# Groundwater Transfer Review Summary Form

Transfer/PA # T- 14106

Application: T-14106      Applicant Name: Fred Ronald Barnes and Dawn Catherine Barnes

## Transfer Review Map

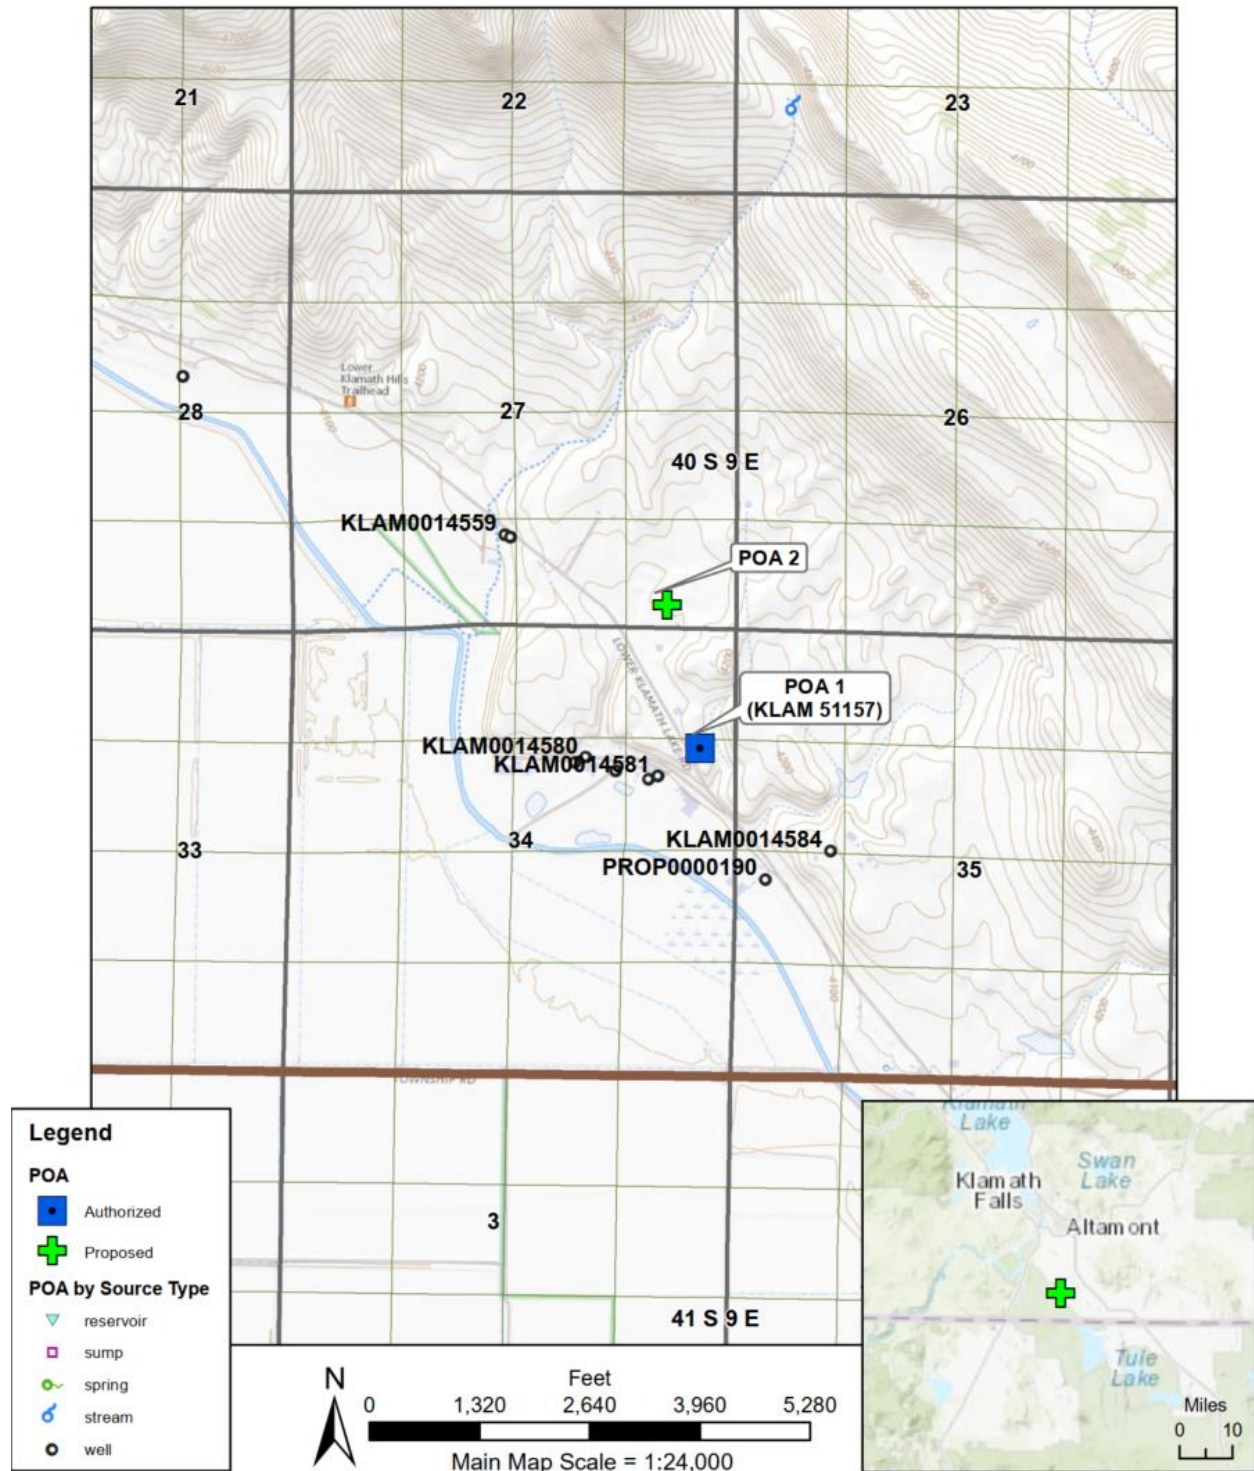
2. Will the proposed POA develop the same aquifer (source) as the existing authorized POA?  
☐ Yes    ☒ **No**    Comments: The proposed APOA **POA 2** is located approximately 1700 feet to the north of authorized **POA 1**. The construction of **POA 1** as documented on well report **KLAM 51157** indicates a total depth of 360 feet below land surface (bls) and a seal depth to 200 feet bls. The well report lists that two water bearing zones were encountered: (1) 82 to 92 feet bls with a SWL of 55 feet bls and (2) 312 to 360 feet bls with a static water level of 83 feet bls. The well report indicates that the shallow water encountered at 82 feet bls was "cold" and not suitable for the intended use. The temperature of water sourced from the deeper water bearing zone was listed as 184 degrees Fahrenheit. Only the deeper water bearing unit between 312 to 360 feet bls is developed by **POA 1**.

The proposed construction for **POA 2** is 360 feet total depth and a seal to 38 feet bls. This proposed seal depth could leave the well open to the colder, shallow water bearing unit and allow for comingling of deeper, hotter water and, therefore, would not develop the same (single) source as authorized **POA 1**. See section 7 of this review form for recommend conditions and changes.

4. a) Will this proposed change, at its maximum allowed rate of use, likely result in an increase in interference with **another ground water right**?  
☒ Yes ☐ No Comments: Proposed APOA POA 2 is approximately 2000 feet from **KLAM 14559** an authorized POA under groundwater permit **G-17708** with a junior priority date of 3/9/2001 compared to the approximately 4000 feet from authorized **POA 1**. The reduced intervening distance from the proposed APOA **POA 2** has the potential to increase interference with **KLAM 14559**.

7. What conditions or other changes in the application are necessary to address any potential issues identified above: The applicant's proposed seal depth should be deep enough to ensure that comingling of colder shallow water and deeper geothermally heated water does not occur. It is recommended that the proposed well be cased and sealed to a minimum depth of 325 feet bls in order to isolate the hydrothermally heated groundwater at depth. It should be noted that the final construction of the proposed POA will need to meet well construction standards per OAR 690-210 and final sealing depth may need to be deeper than the recommended 325 feet below land surface based on conditions observed during drilling.
